**RE:** Mesa Cold Storage Repave Project  
Grading and Drainage Plan  
Engineer's Stamp Date 2-7-2017 (Fil: H13D108)

Based upon the information provided in your submittal received 2-8-2017, the above referenced Grading and Drainage Plan cannot be approved for paving permit until the following comments are addressed:

ENGINEER'S SEAL	MESA COLD STORAGE	DRAWN BY WCWJ
	GRADING AND DRAINAGE PLAN	DATE 2-07-17
		21707-LAYOUT-2-07-17
DAVID SOULE P.E. #14522		1606 CENTRAL AVENUE SE SUITE 201 ALBUQUERQUE, NM 87106 (505) 872-0999
		JOB # 21707

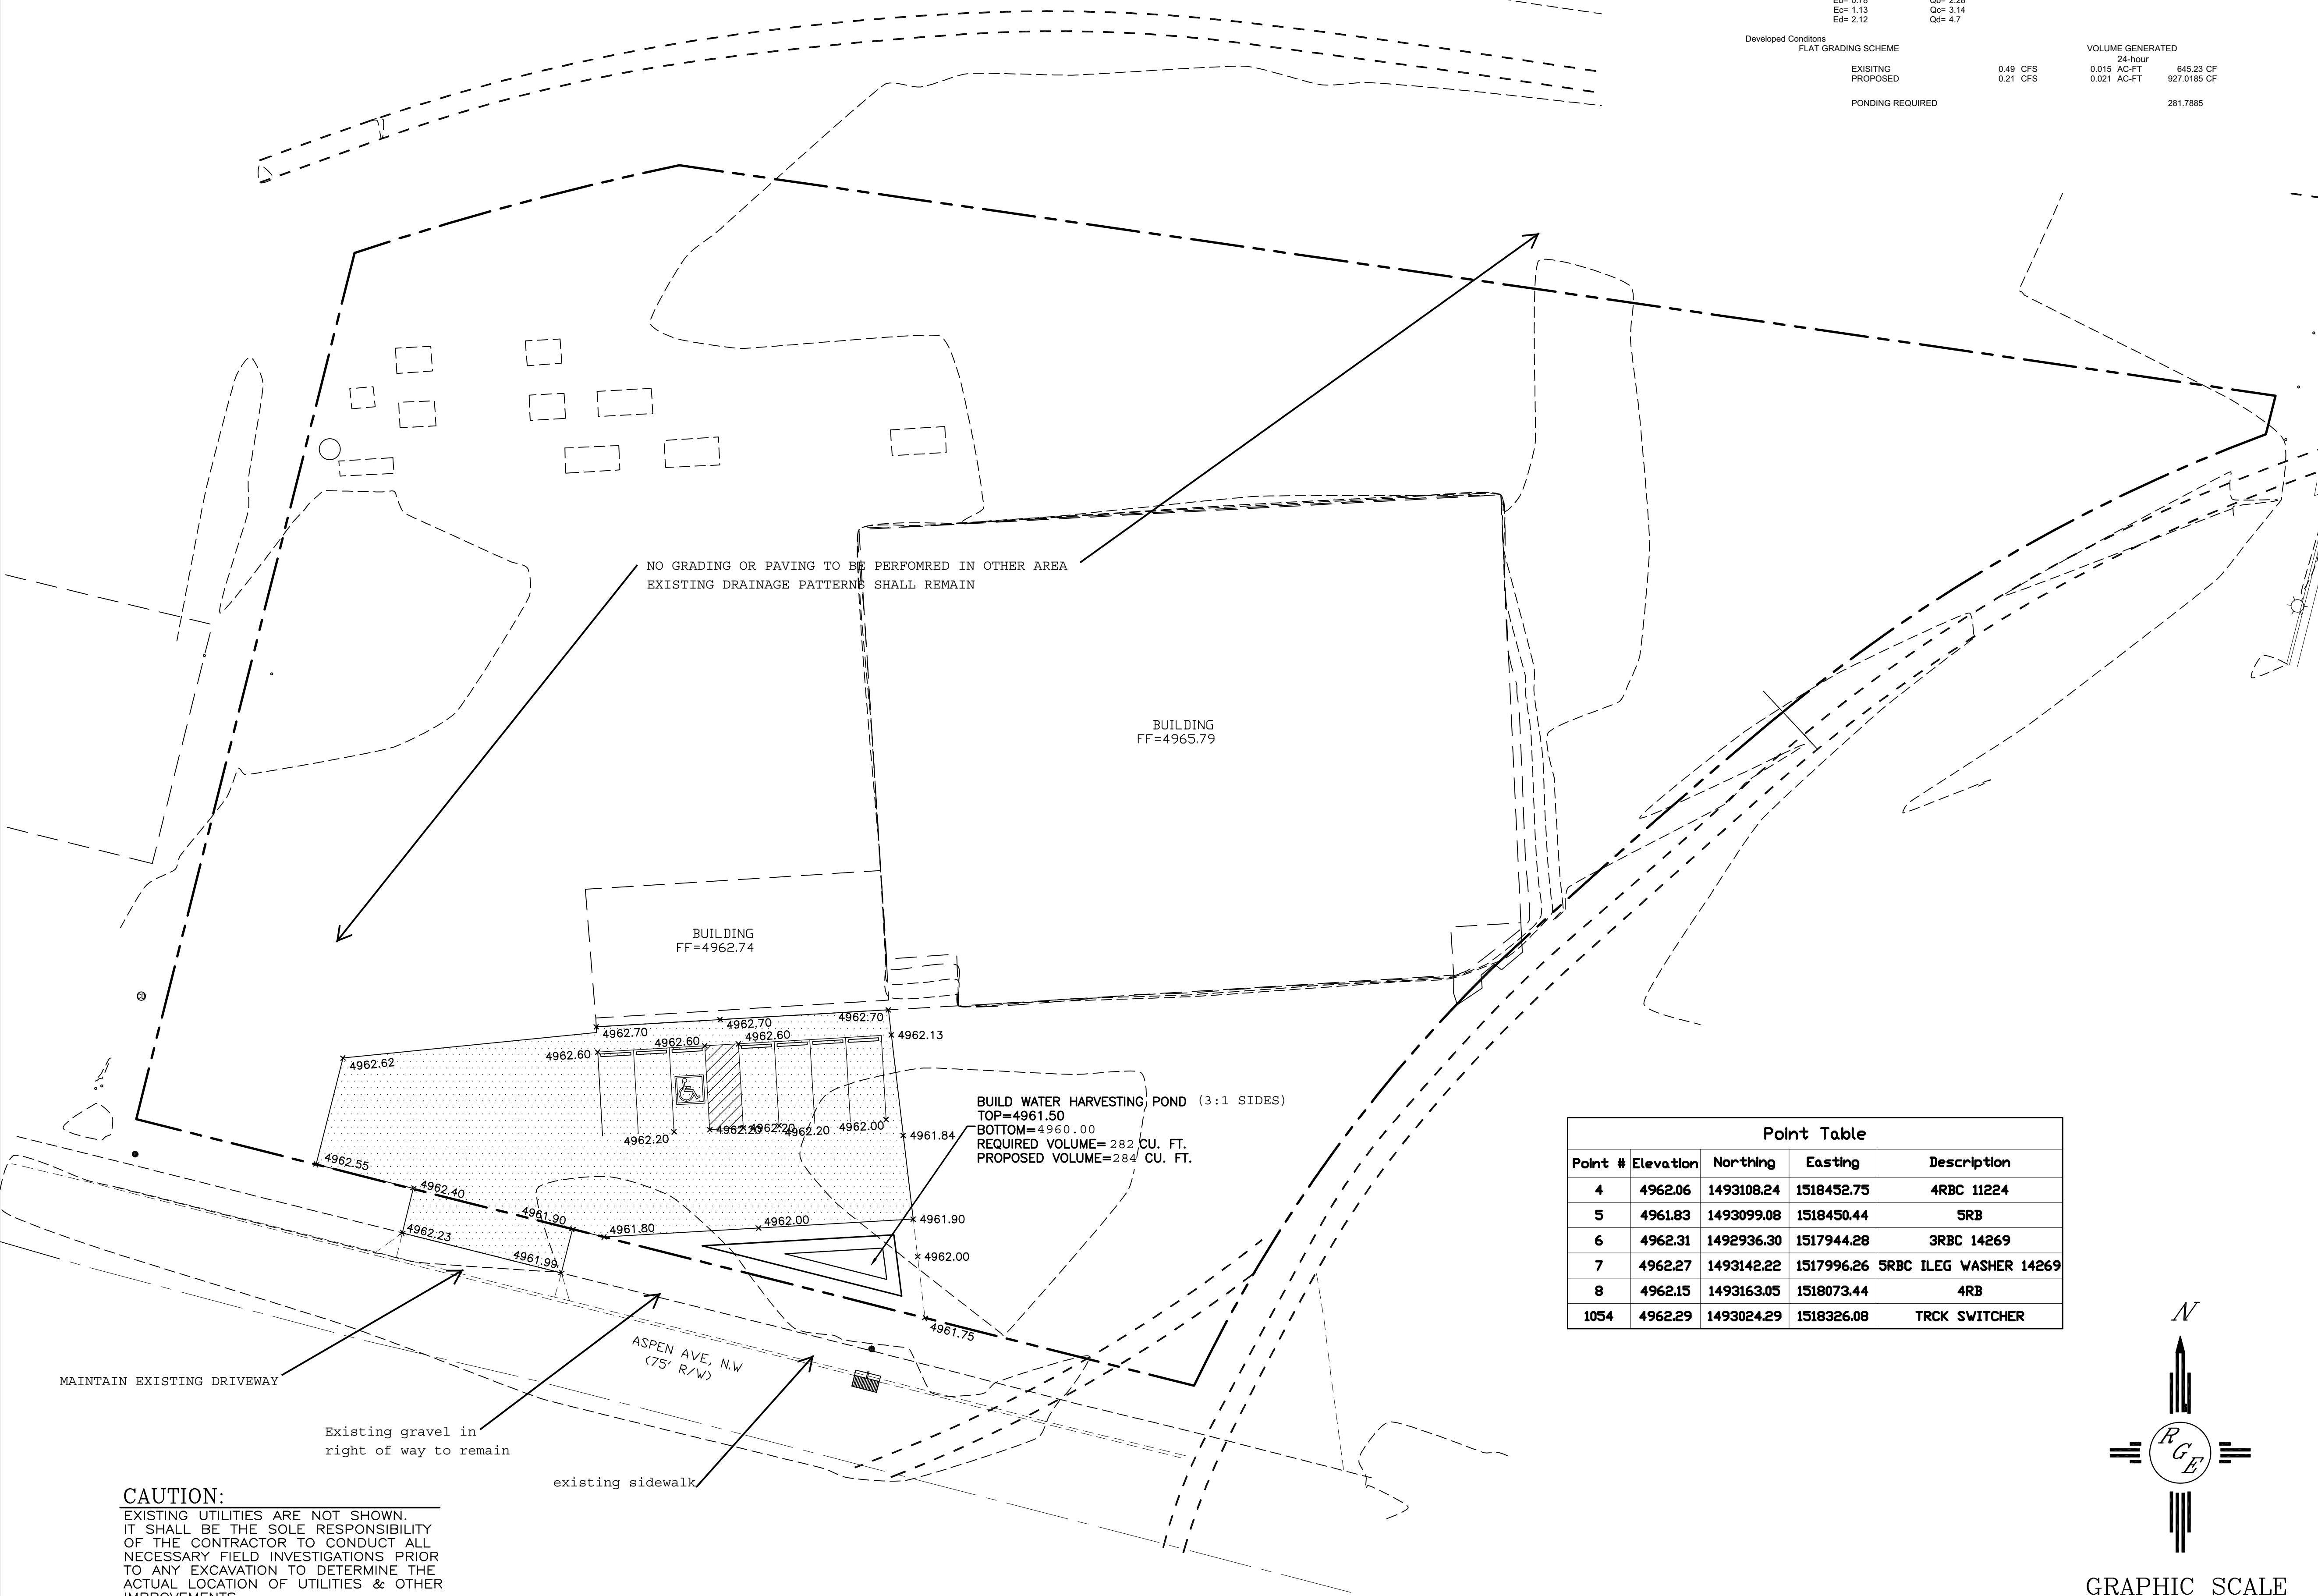
1. Provide onsite and offsite flow narrative.
2. It's not clear if the proposed grade tie to the existing grade.
3. Existing driveway must meet ADA requirement. The area between sidewalk and property line is consider part of the drive way.
4. Show flow line elevation by the driveway. Do we adequate water block?
5. Fix the text overlaps.
6. Parking restriping and handicap parking signage must be coordinated with transportation.
